**State of Alaska
Department of Fish and Game
Sportfish Division**

**Nomination Form
Anadromous Waters Catalog**

Region Southcentral USGS Quad(s) ANCHORAGE C-5
 Anadromous Waters Catalog Number of Water Body 247-50-10220-2110
 Name of Water Body _____ USGS Name Local Name
 Addition Deletion Correction Backup Information

Nomination #	25-835	<i>[Signature]</i>	<u>2/4/2026</u>
		Fisheries Scientist	Date
Revision Year:	2026	<i>[Signature]</i>	<u>2/4/26</u>
		Habitat Operations Manager	Date
Revision to:	<input checked="" type="checkbox"/> Atlas <input checked="" type="checkbox"/> Catalog	<i>[Signature]</i>	<u>2.4.26</u>
		AWC Project Biologist	Date
Revision Code:	B-2	<i>[Signature]</i>	<u>2/4/2026</u>
		GIS Analyst	Date

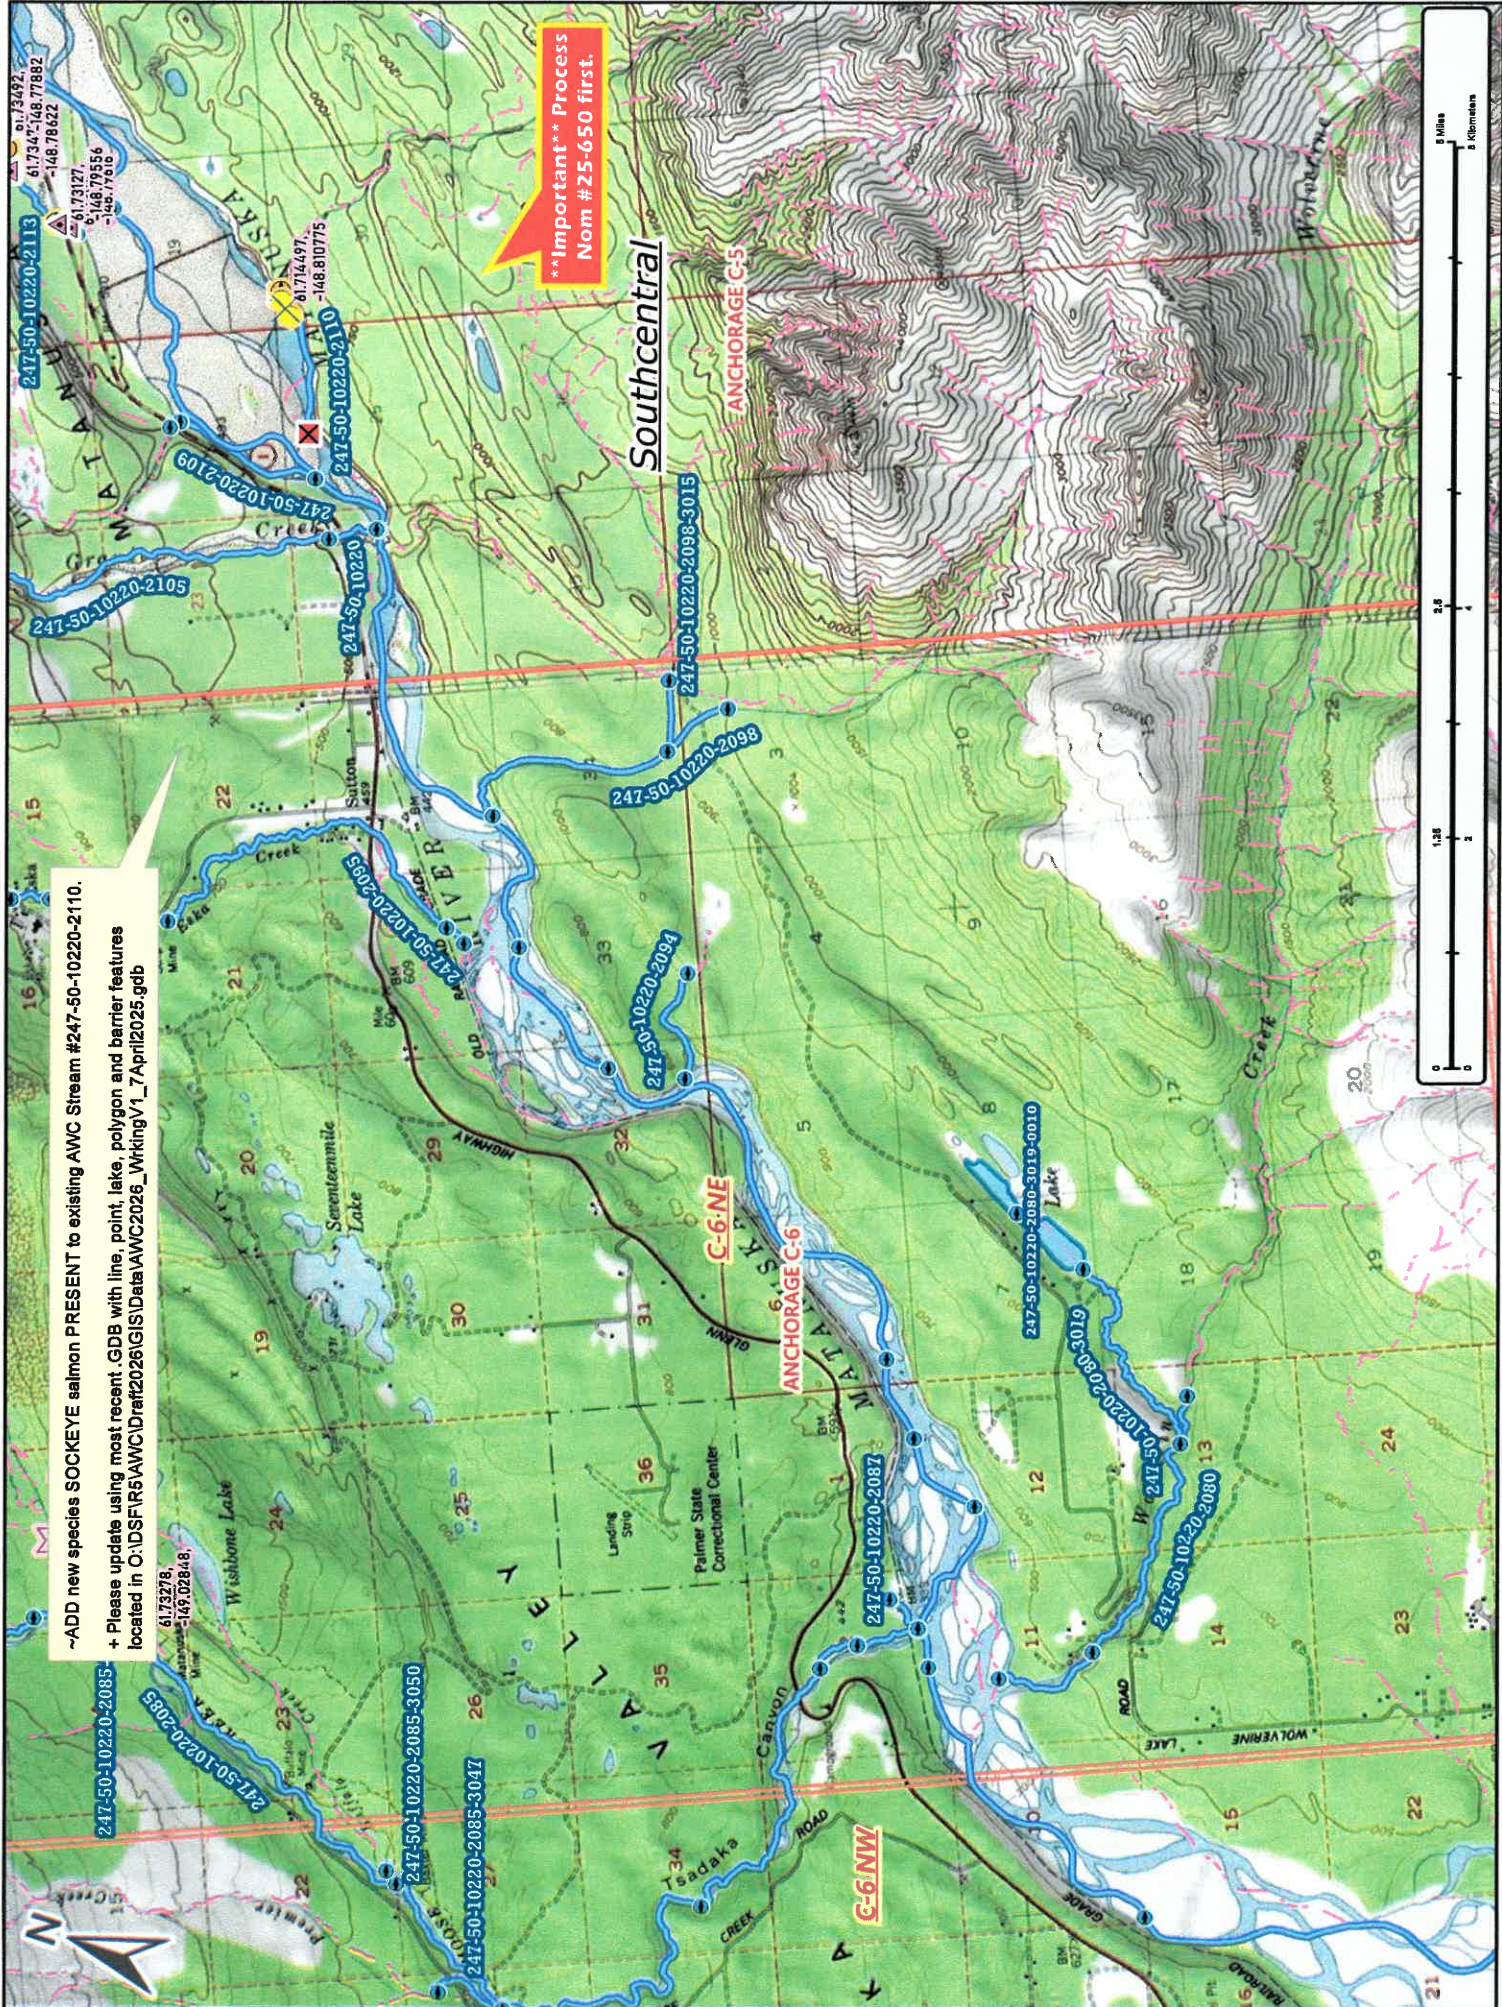
~ADD new species SOCKEYE salmon PRESENT to existing AWC Stream #247-50-10220-2110.
****Process Nom #25-650 first****

Comments:
 Chickaloon Village Traditional Council Environmental Stewardship staff Benjamin Americus and Cody Henrikson visited this stream via packraft to observe adult fish during spawning season. We observed 40 sockeye adults and a few carcasses in the silty water slough near the confluence of the Matanuska River (61.714497, -148.810775). This slough was clear-water on our last visit on 7/23/2025. Turbidity in this slough seems to be influenced by stage and lateral migration of the Matanuska River.
 Coordinates (Lat,Long): Upper(61.71450,-148.81078) Lower(61.71391,-148.81342)
